HISTORIC AND DESIGN REVIEW COMMISSION

October 17, 2018

HDRC CASE NO: 2018-451
ADDRESS: 607 E LOCUST
LEGAL DESCRIPTION: NCB 1735 BLK 14 LOT 3
ZONING: MF-33 H
CITY COUNCIL DIST.: 1
DISTRICT: Tobin Hill Historic District
APPLICANT: Jose Calzada/Architectura SA
OWNER: Rafael Saavedra Sada/Aster Development LLC
TYPE OF WORK: Construction of three, three story townhomes
APPLICATION RECEIVED: September 19, 2018
60-DAY REVIEW: November 18, 2018
REQUEST:

The applicant is requesting conceptual approval to construct three, three story townhomes on the vacant lot addressed 607 E Locust.

SCHEMATIC DESIGN

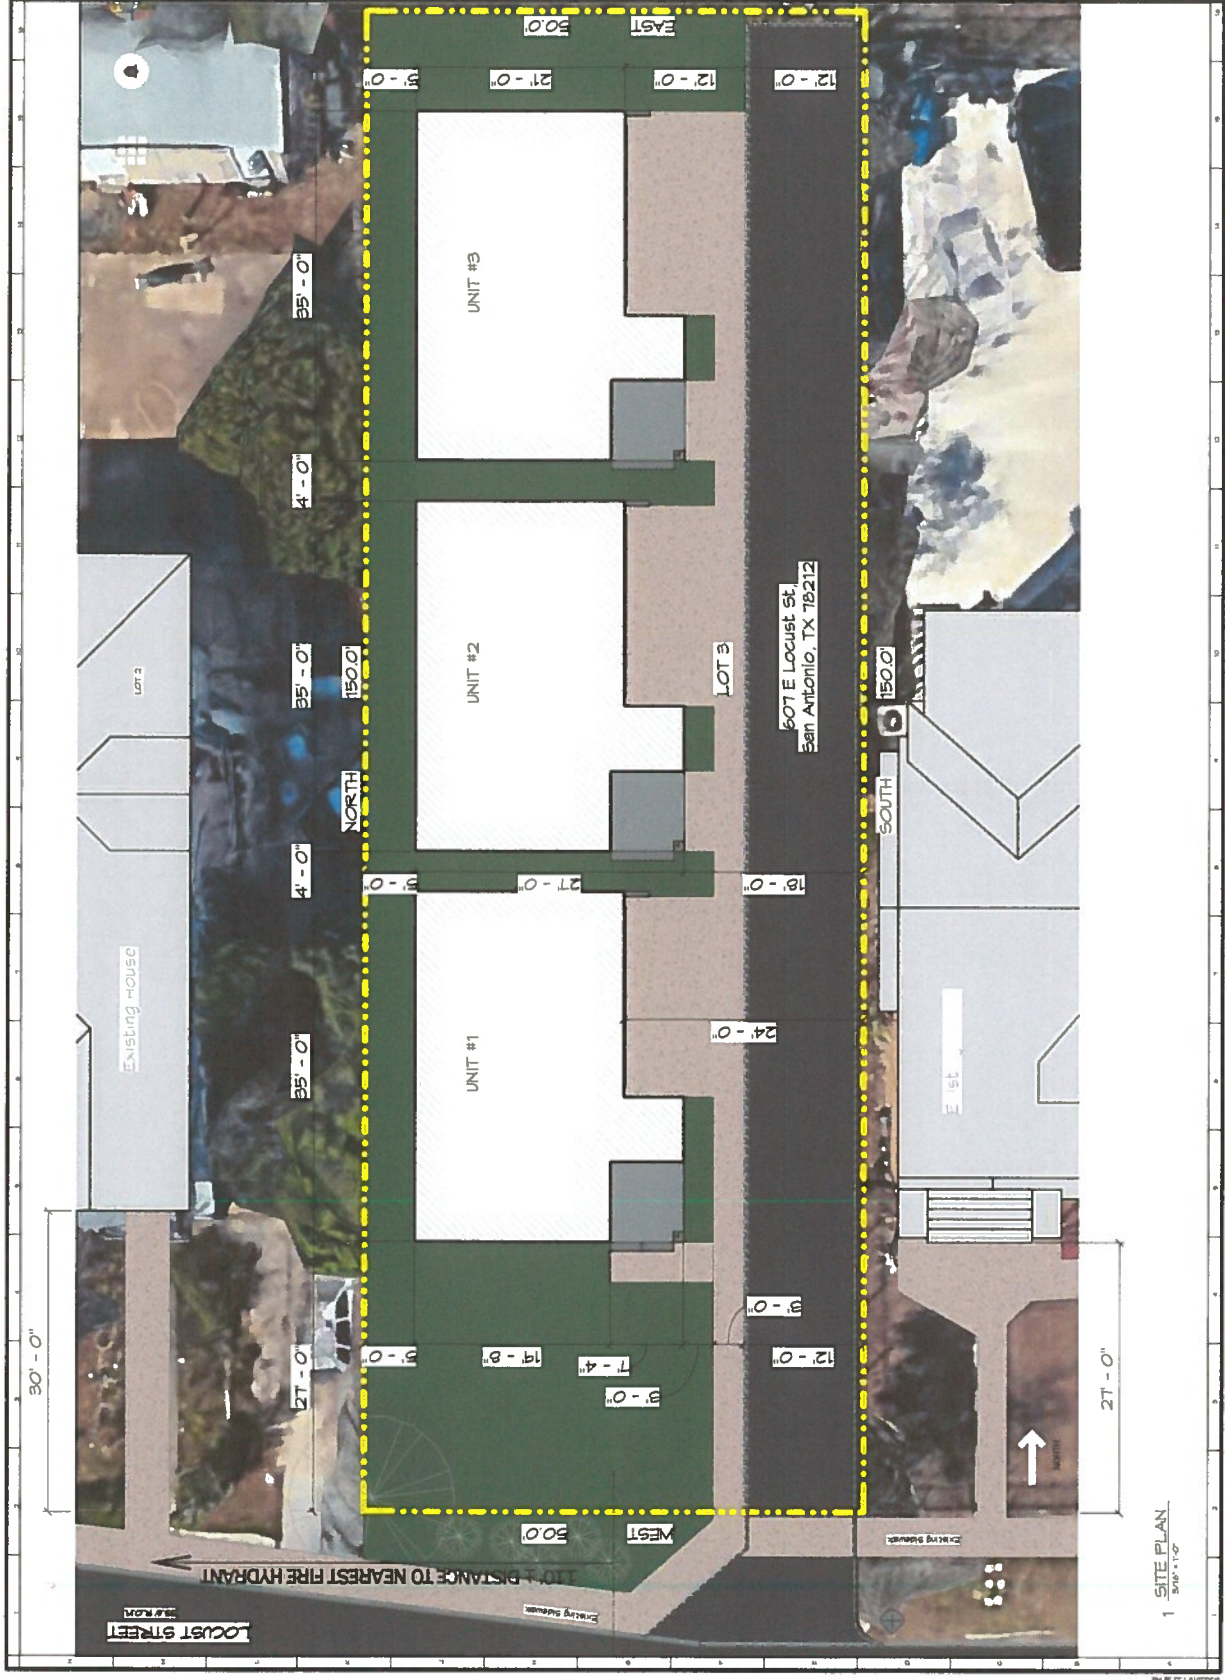
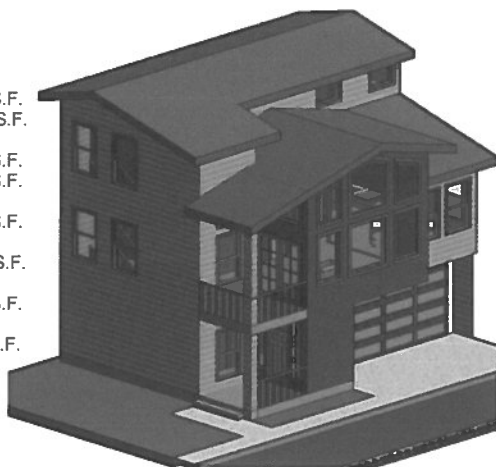
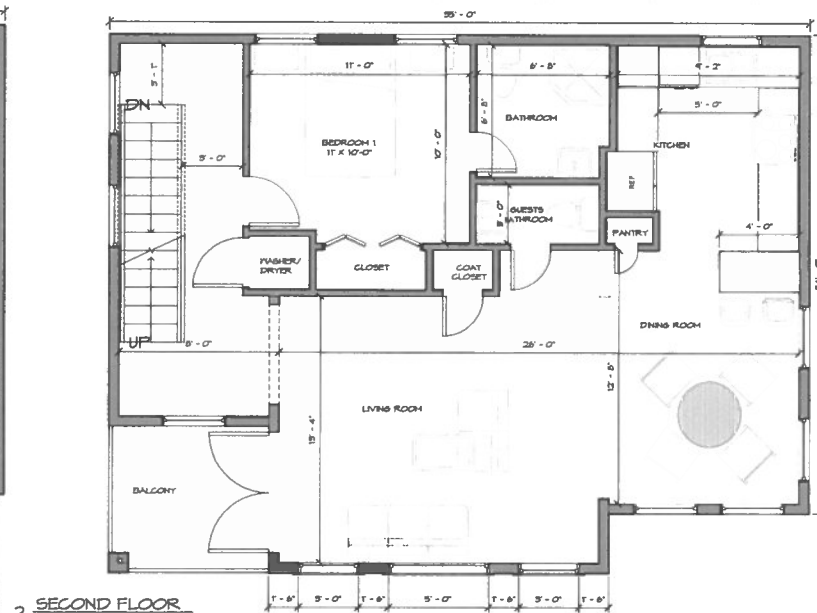
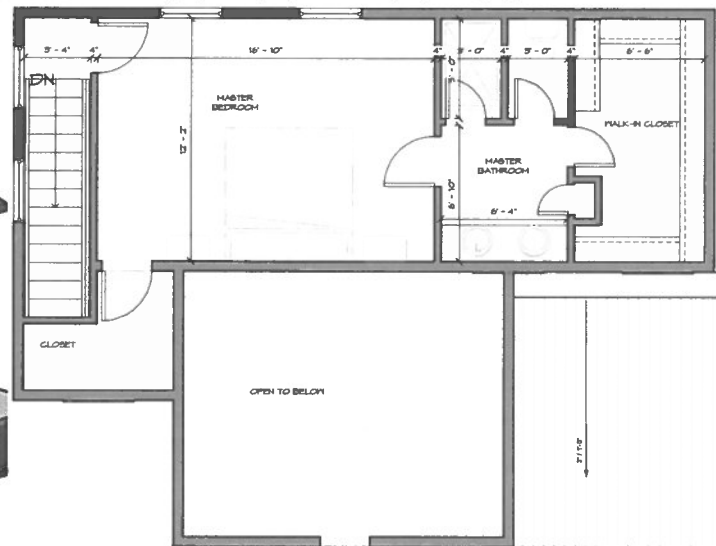
- g. **SCALE & MASS** – The applicant has proposed three detached 3-story units. One will be located along the street frontage of E Locust, and two will be located in the rear of the property. Per the submitted elevations, the ridgeline of the units is approximately 32'. Guideline 2.A.i stipulates that the height and scale of new construction should be consistent with nearby historic buildings and should not exceed that of the majority of historic buildings by more than one-story. Per the submitted elevations, the applicant has indicated that the 2-story historic structures directly to the east and west are approximately 30-31 feet. While there are taller structures throughout the district, staff finds that a 2-1/2 story structure would be more appropriate for the overall context of the block, which includes 1-story structures immediately to the south. Staff finds that the overall height should be lowered to be more consistent with the Guidelines.

- i. **ROOF FORM** – The applicant has proposed an asymmetrical gable roof form. Staff finds that the overall roof form is a departure from existing precedents based on its scale and configuration. As proposed, the overall roof forms are not consistent with precedents in the district or the Historic Design Guidelines. Staff finds that a traditional gable roof form would be more appropriate for the immediate context of the block.

- j. **PORCH** – The applicant has proposed a double height recessed porch on the east side of the front unit. The porch features a traditional railing based on the submitted renderings with a depth of approximately 8 feet. According to the Historic Design Guidelines, new construction should not attempt to mirror or replicate historic features, and new structures and design elements should not be so dissimilar as to distract from or diminish the historic interpretation of the district. The conceptual porch configuration pulls from the historic structure located 2 houses to the west. However, this precedent features a higher foundation height and stairs that engage the streetscape leading from the front porch. Staff finds that further articulation of the porch as an element geared towards the pedestrian experience is required to be more consistent with the Guidelines and development pattern of the block and the district.

- q. HARDSCAPING – The applicant has proposed a 12 foot wide central driveway on the eastern edge of the property. The Guidelines state that driveway should be a maximum of 10 feet to comply with the historic development patterns of the district. Staff finds that the width should be reduced.

COMMENTS/CONCERNS: PROPOSED HEIGHT IS 38' (APPROXIMATELY).
ADJACENT 2-STORIES ARE APPROX. 31'-36'.
ACROSS THE STREET IS ALL 1-STORY HOMES.
ADJACENT FRONT SETBACK IS 25'; PROPOSED
SETBACK IS 19' (APPROXIMATELY).
HOUSES IMMEDIATELY ADJACENT ARE WOOD.

OVERALL HEIGHT IS CLOSE TO ADJACENT BUT STILL ~5' TALLER. PLATE HEIGHTS?

12', 8', 10' - ~~ADD~~ SHOULD BRING PLATE DOWN, OR HIPPED ROOF ON ~~FRONT~~ FACADE TO REDUCE "LOOMING" NATURE.

CF: COULD GIVE YOU OPPORTUNITY TO GAIN SPACE FOR FRONT UNIT. GARAGE ELEVATION ON FRONT ~~W~~ MIGHT BE ISSUE w/ COMMISSION. COULD REDUCE PRESSURE ON 3RD STORY. MIGHT BE TOO MUCH PRESSURE ON SITE FOR 4 TOWERS, MIGHT HAVE OPPORTUNITY FOR 3 LARGER / BETTER UNITS, ~~IN~~ PRIMARY / ACCESSORY STRUCTURE RELATIONSHIP. NEED TO SET BACK FRONT UNIT, INCLUDING A TRUE PORCH.

MG: 18" FOR FOUNDATION HEIGHT WOULD BE MOST APPROPRIATE MAY NEED STEP DOWN INTO GARAGE.

- ii. That the applicant explores 2.5-story massing options to respond to the dominant historic massing context of the neighborhood as noted in finding g.

- iii. That the applicant incorporates roof forms that are more consistent with the typologies found in the Tobin Hill Historic District as noted in finding i.

- iv. That the applicant incorporates a foundation height of at least 18 inches to be more consistent with the foundation heights of nearby historic structures as noted in finding h.

- viii. That the applicant reduces the proposed driveway width as noted in finding q.
